SECTION 009113 – ADDENDUM TWO

- A. Project Name: 22034.03 Meridian High School Baseball/Softball Rebid
- B. Owner: Meridian Public School District, 1019 25th Avenue, Meridian, MS 38391
- C. Architect: Dale | Bailey, an Association, One Jackson Place, Suite 250, 188 East Capitol Street, Jackson, MS 39201-2100
- D. Architect Project Number: 22034.03
- E. Date of Addendum Two: 18 August 2023

1 Floor Plans - Field House Alternate #1
1/4" = 1'-0"

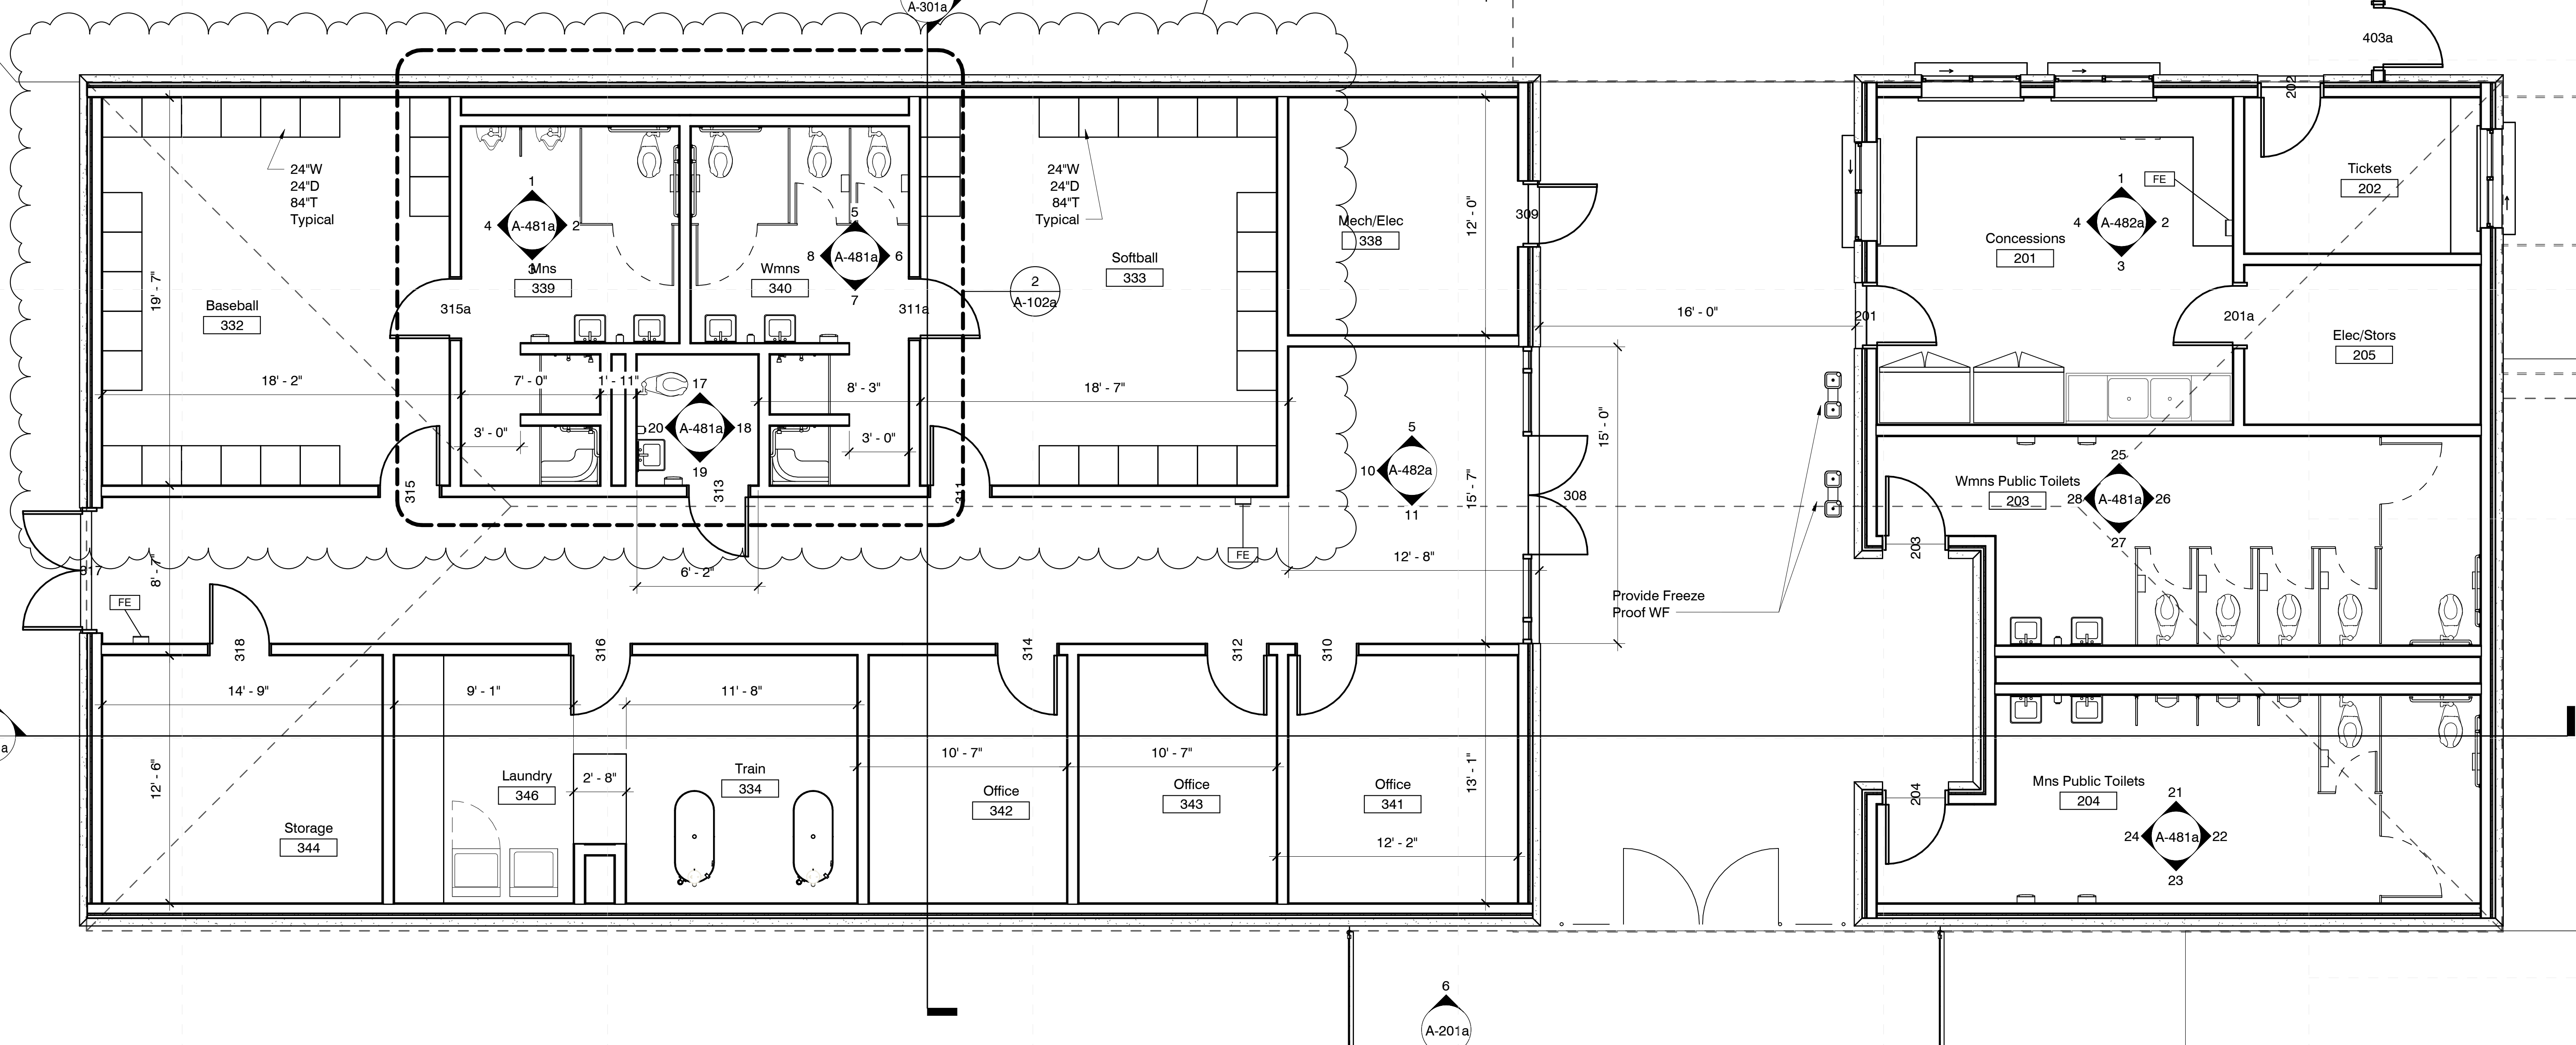
- A. Question: Are the lockers still included in this scope of work? They are listed in the specs but do not appear in the drawings.
Answer: Yes. See updated drawing sheet A-102a.
- B. Question: Product Approval/ Lighting proposal: Ephesus Luma Sport 8.
Answer: Rejected. Photometric layouts have not been included in the submission.
- C. Question: It is unclear to me where and how the 3/4" OSB is attached to the structure and whether there is anything between the plywood and the metal deck, therefore it is unclear how I can attach the shingles to the plywood.
Answer: Fasten Plywood directly to Metal roof deck using self-tapping screws with pan or bugle heads and a minimum of 1 screw per square foot. Install shingles with 1" nails.

- Answer: Exterior glass shall be 1" Insulated.
- H. Question: I am writing to you on behalf of GRID, a Dallas-based manufacturer and installer of Lockers and Sports Flooring. We were contacted to provide a bid for the wood team lockers on this project, but I cannot find any details for the design and number of lockers required.

- A. Architectural Sheet A-102a – Field House Floor Plan – Alternate #1 (Reissued). Delete this sheet in its entirety and replace it with the attached. Added locker layouts.

- Answer: For orientation and count, see updated drawing A102a. See spec section 105116/2.1/A for basis of design. Materials, hardware, and accessories are also noted in same specification section 105116.

C-302
Site Plan

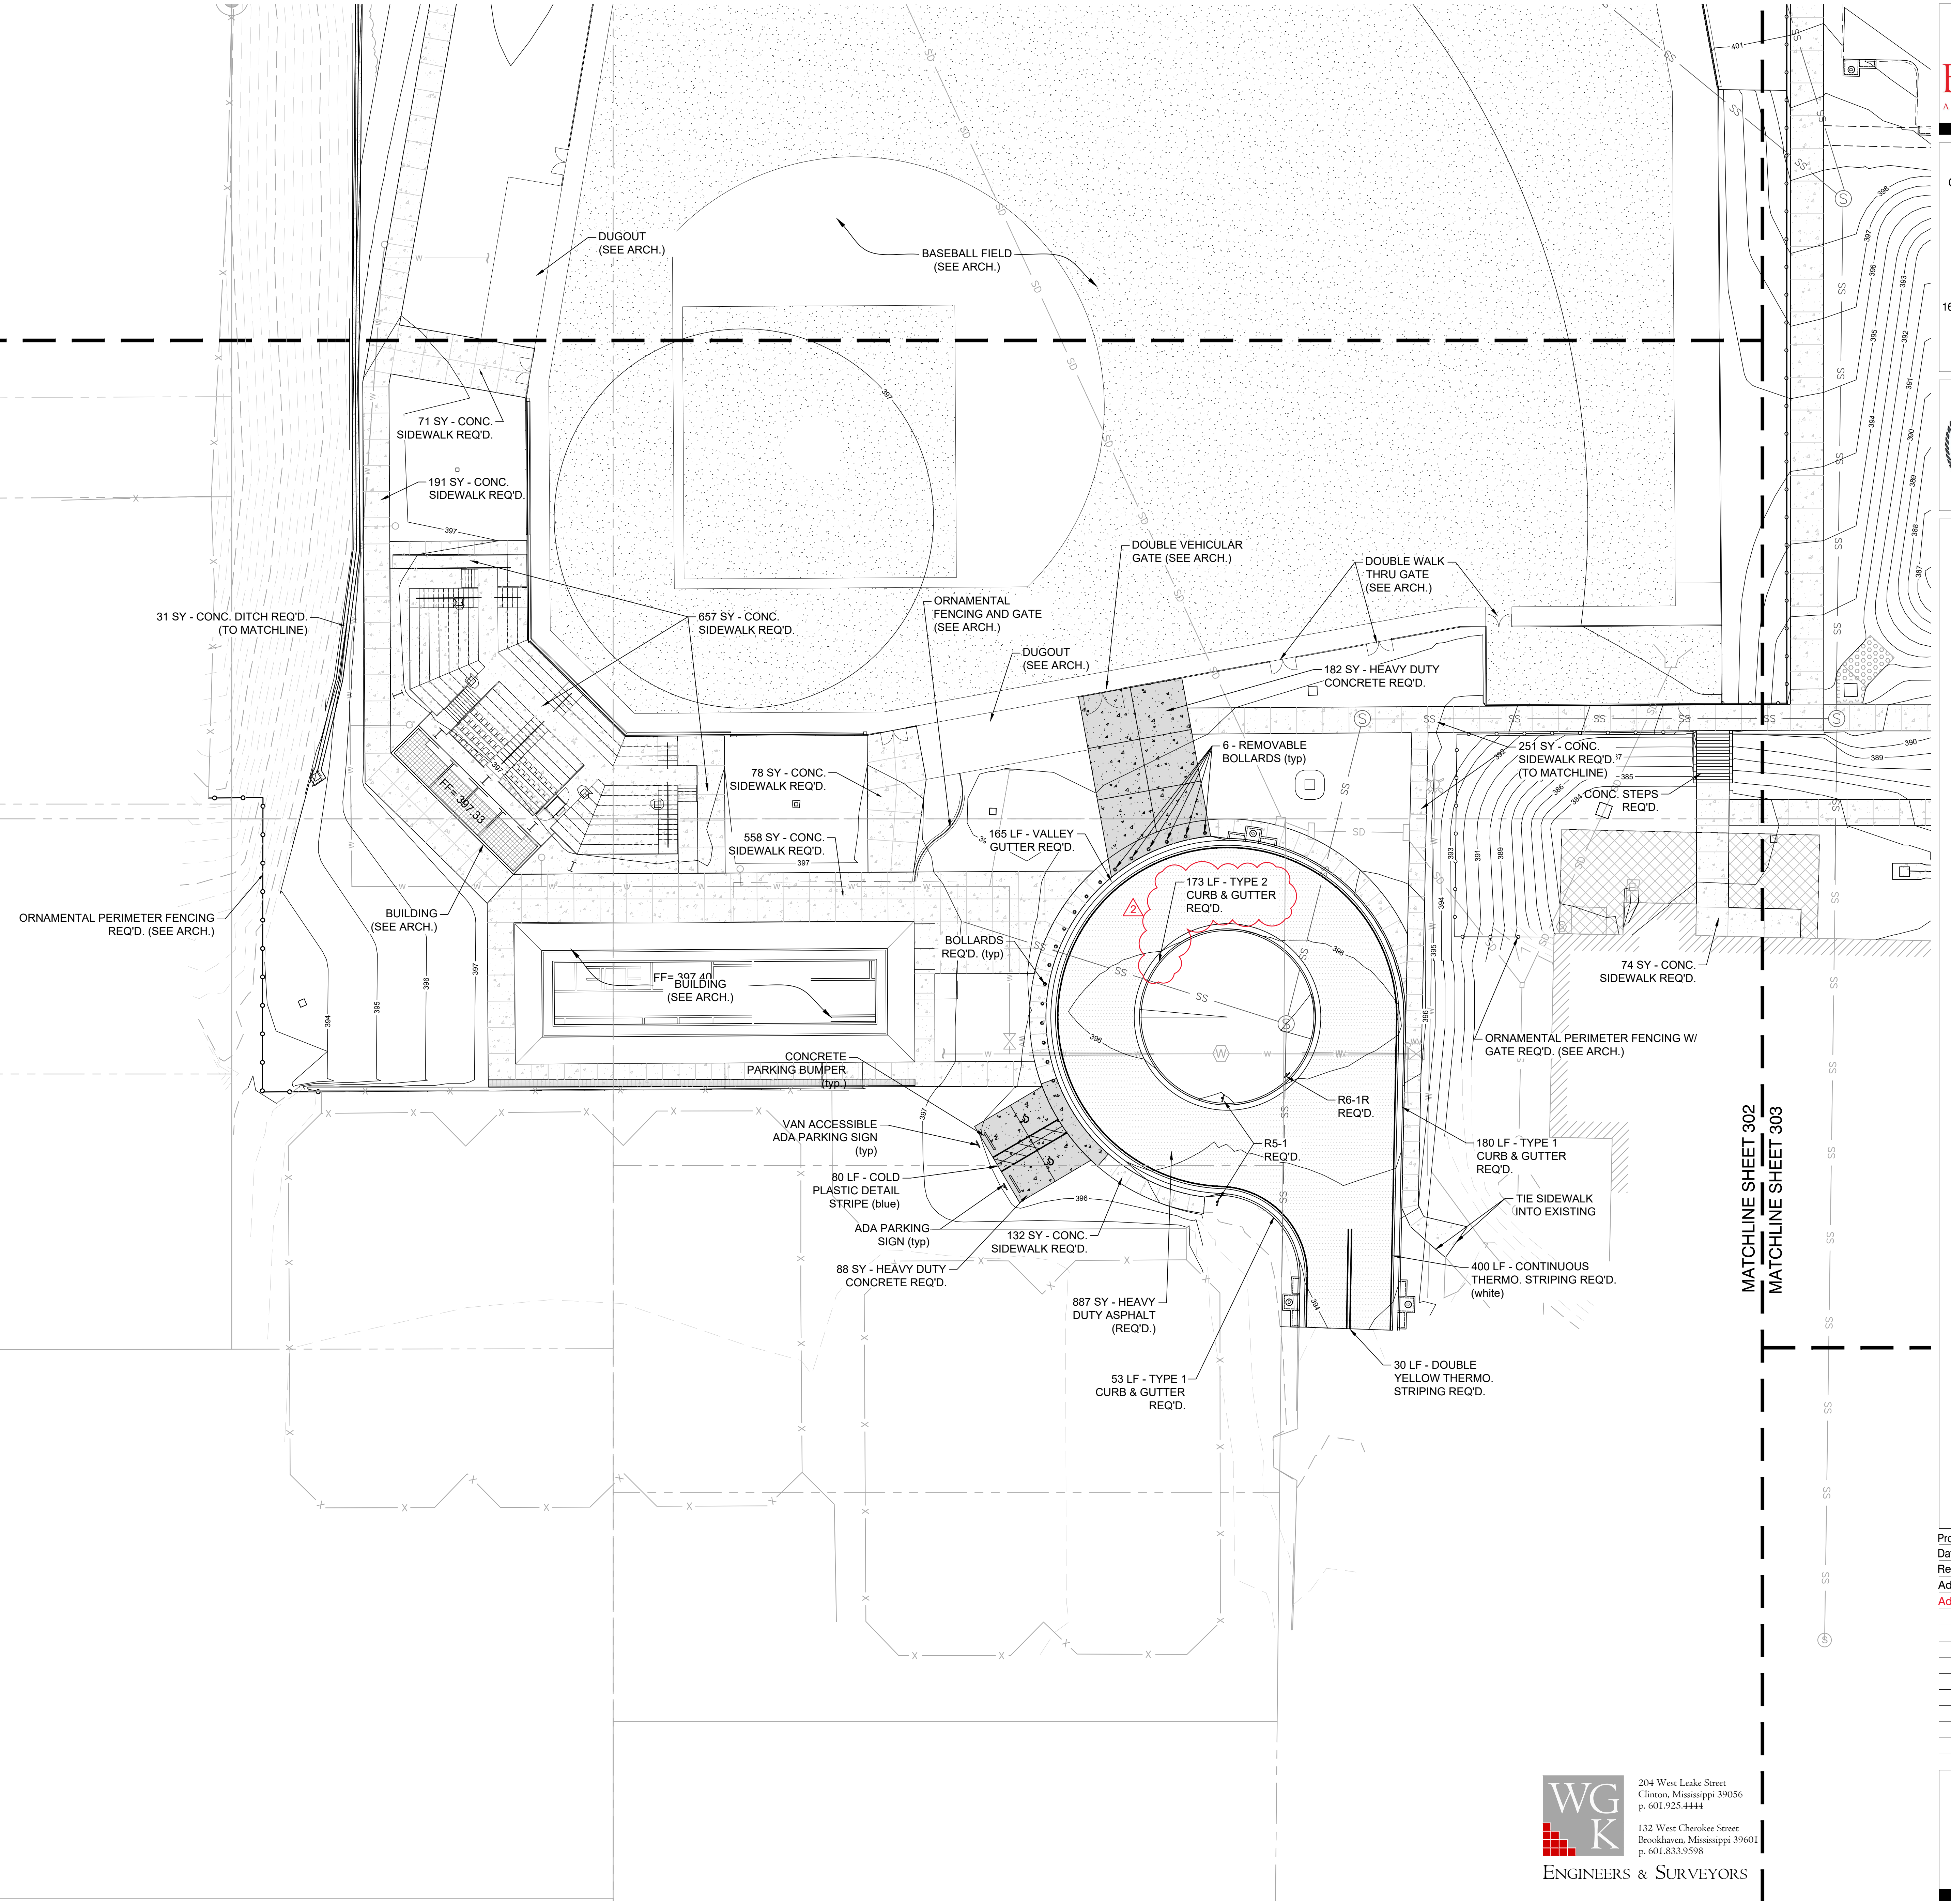
- B. Civil Sheet C-302 – Site Plan (Reissued). Delete this sheet in its entirety and replace it with the attached. Added additional curbing labels and linework.

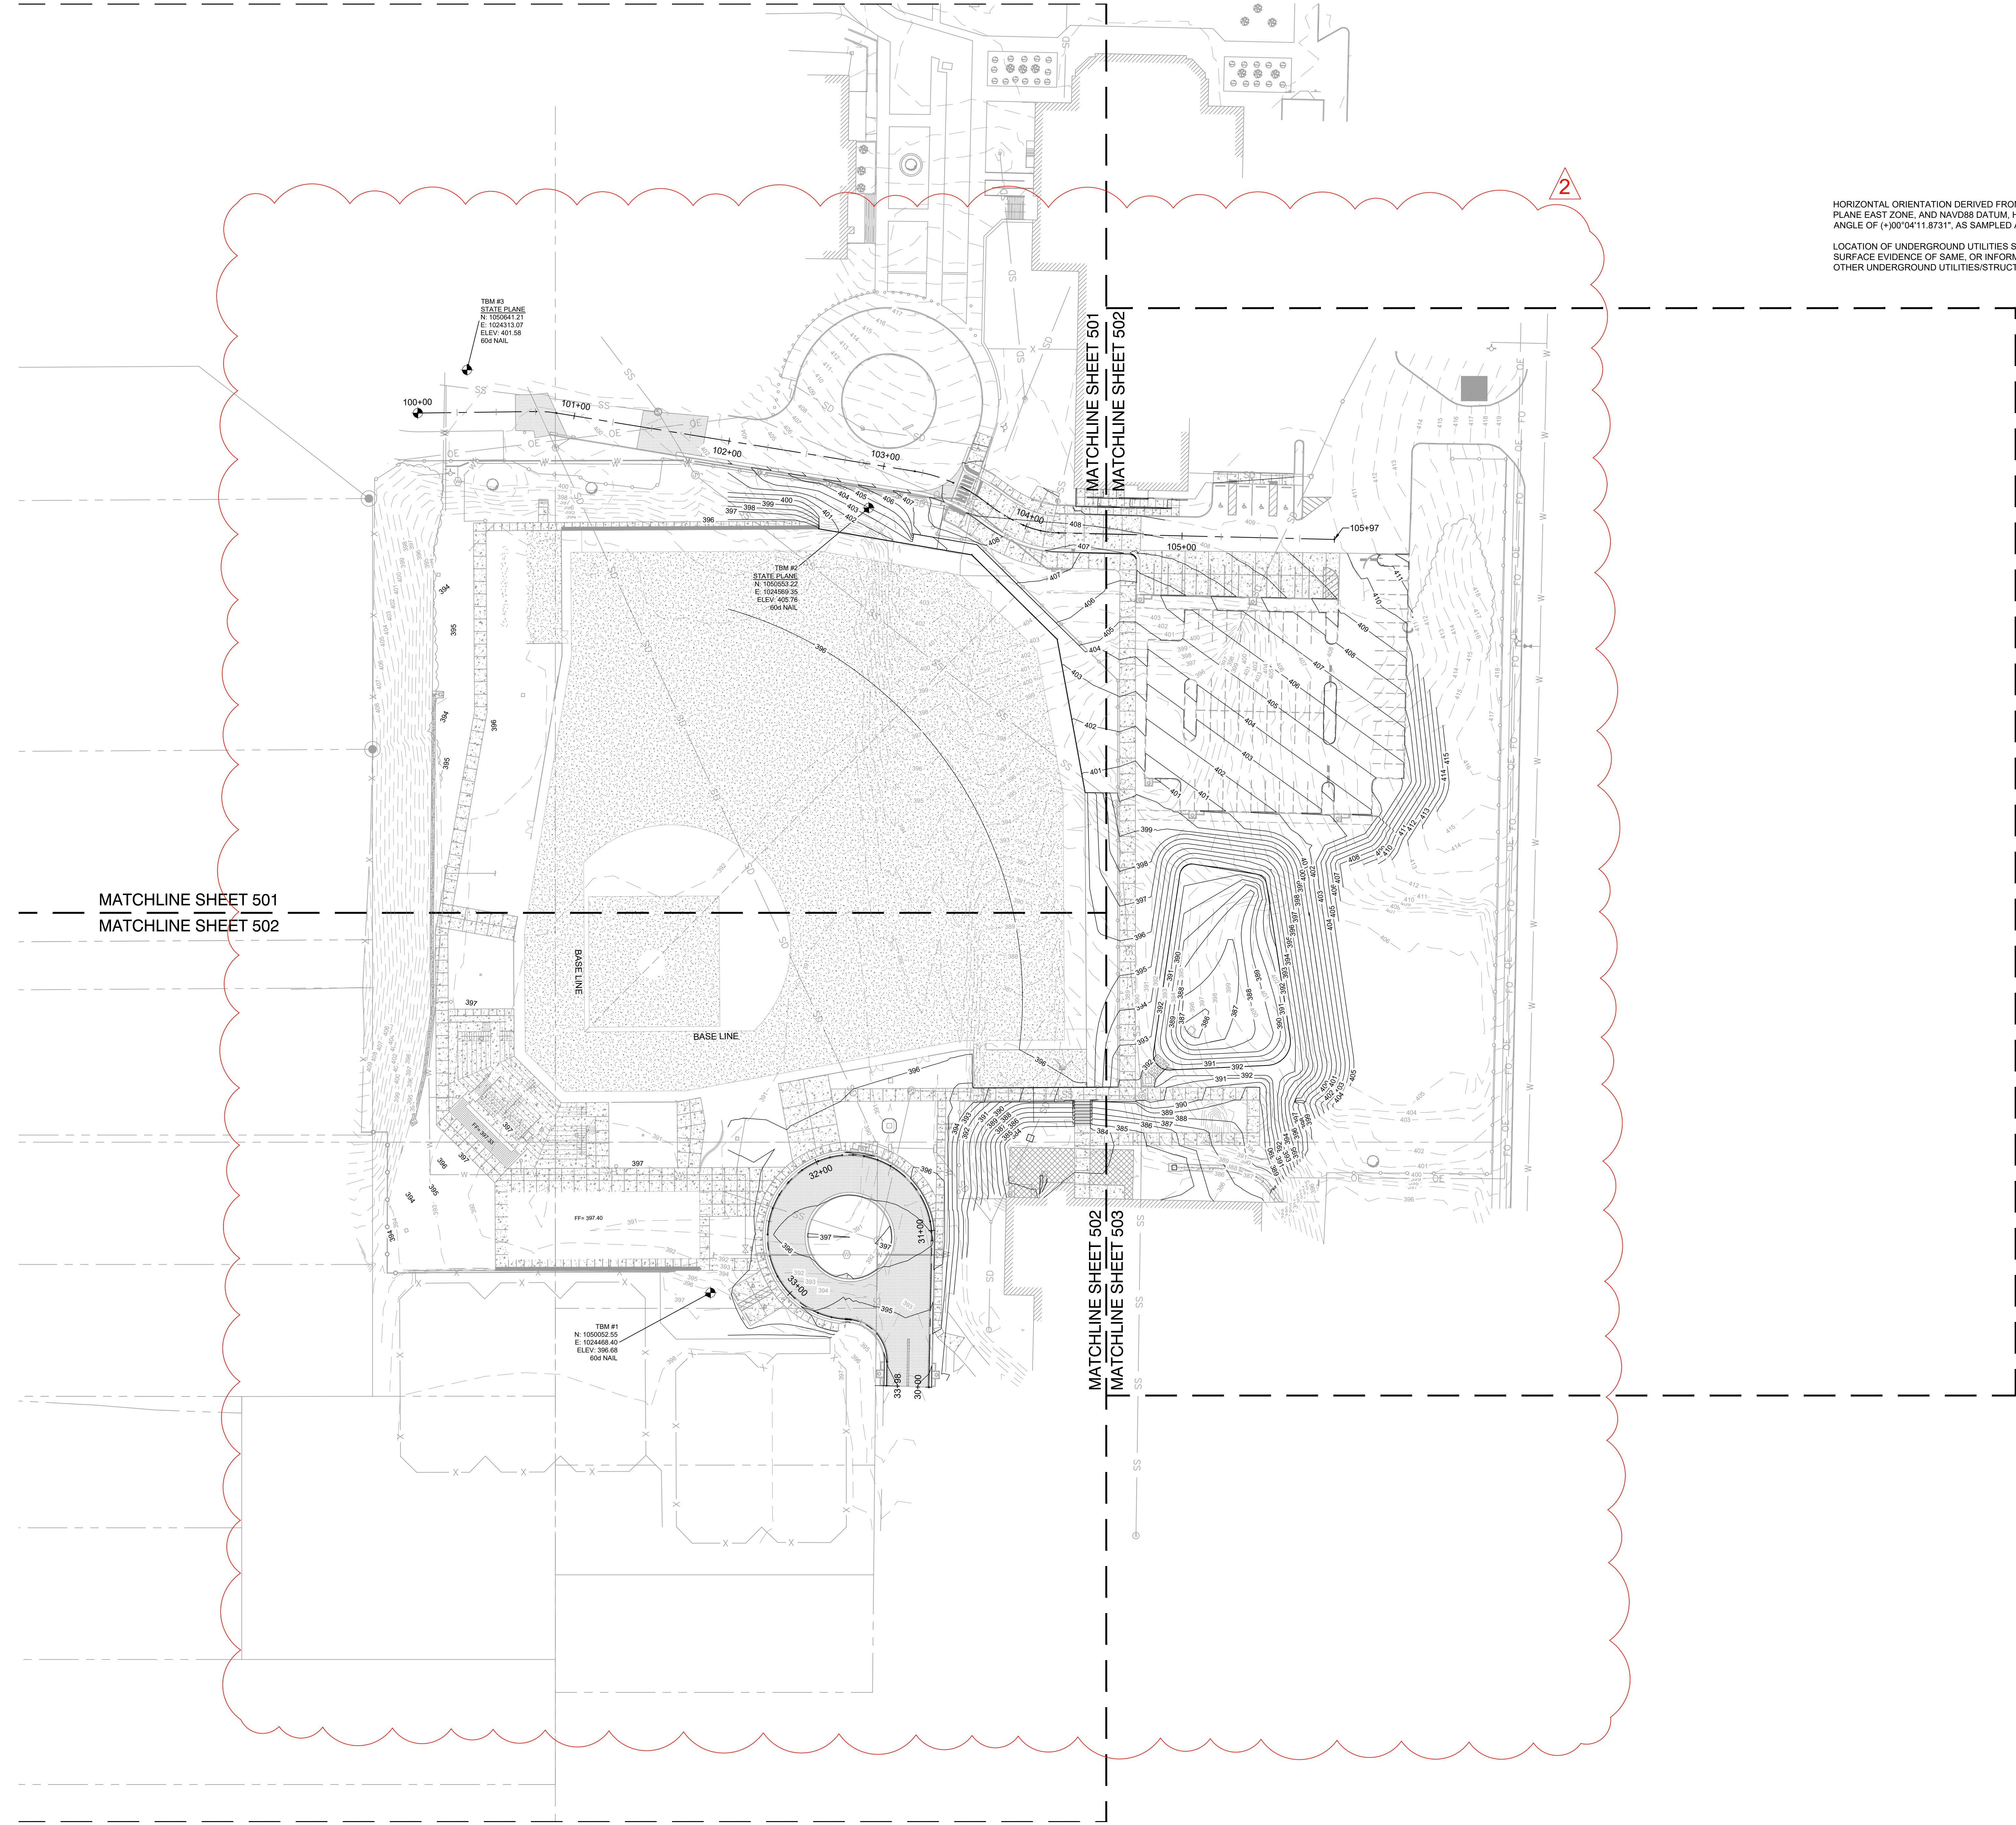
- C. Civil Sheet C-500 – Overall Grading Plan (Reissued). Delete this sheet in its entirety and replace it with the attached. Adjusted contours and added point labels.
